Upper South Creek

Advanced Water Recycling Centre and Pipelines

Flood Emergency Response
CEMP Sub-plan

Document No: USCP-JHG-MPL-ENV-0004
Revision: C

Figure 5-1 Average annual evaporation and rainfall measured (USC AWRC EIS, 2021)

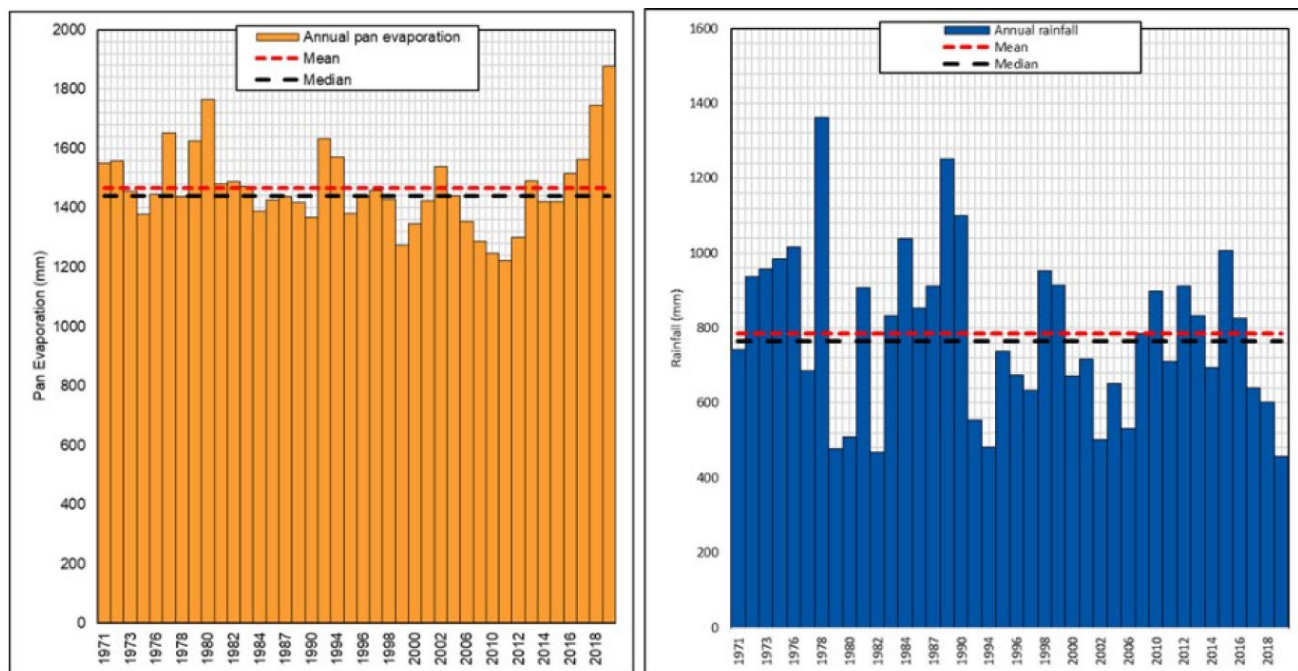
EHG notes that, the Flood Emergency Response CEMP Sub-plan is based on the Flood Impact Assessment provided with the USC AWRC EIS in September 2021. This is significantly concerning to EHG. Table 6 (pg 18) refers to USC AWRC EIS, 2021 and the figures provided in appendix B Figures B.1 to B.3 confirm that the Flood Emergency Response CEMP Sub-plan is not based on the latest flood re-modelling but on the obsolete USC AWRC EIS flood assessment September 2021.

Figure 6-1 Location of compounds (Source: USC AWRC response to request for information 44447594 – flooding, 11 July 2022).

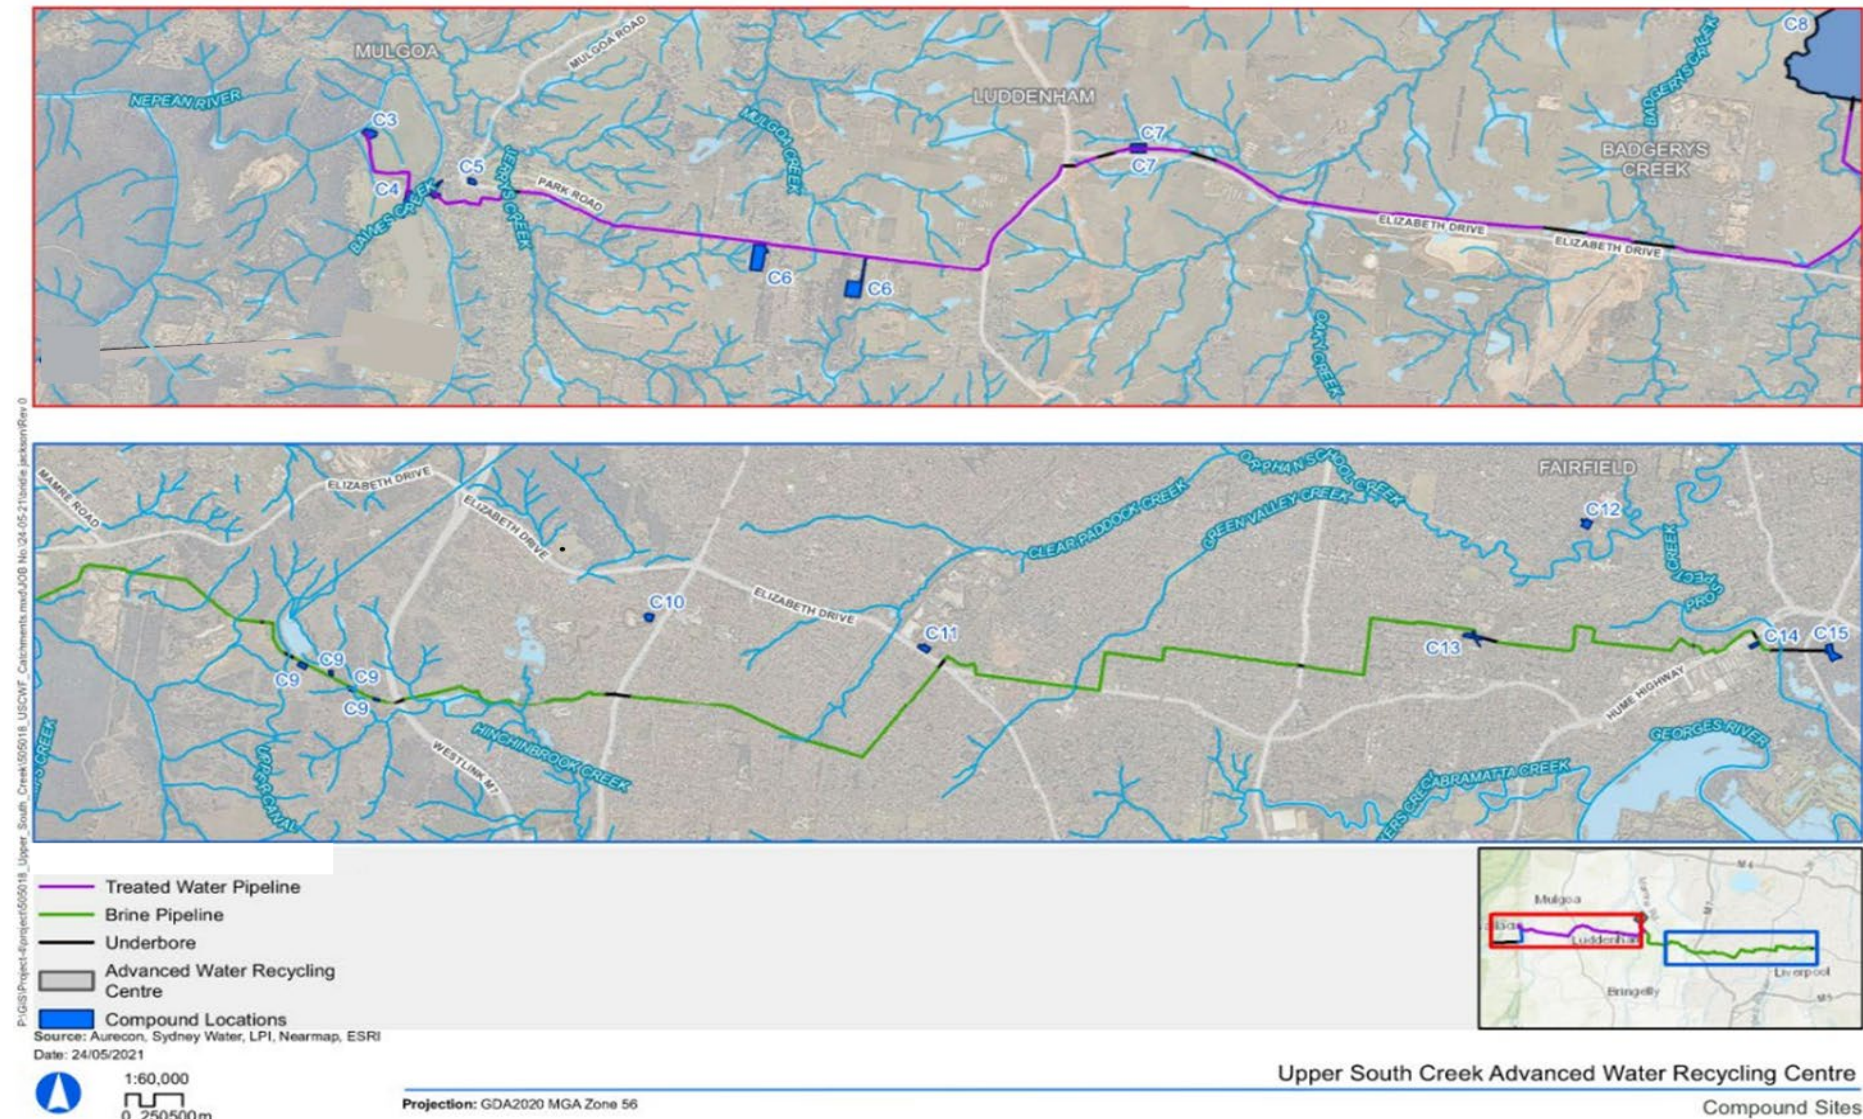
Comment Raised	Date Raised	How Addressed / Justification Why Not Addressed
		The remaining management measures identified in Table 8-1 have been reviewed and are applicable. Management measures have been informed by the updated modelling assessments (i.e. flood extents), updated management measures (UMM) within Appendix B of the Submissions Report, Minister's Conditions of Approval (MCOA) and best practice.
Section 7.2 describes the potential impact on the construction compounds and its significance. The section should provide maps for the location of these compounds (C1 - C15) and the location of Nepean River instream construction works. Without this information it is not possible to review this section.	29/03/2023	Figure 7-1 has been included to show the indicative location of these compounds and water crossings
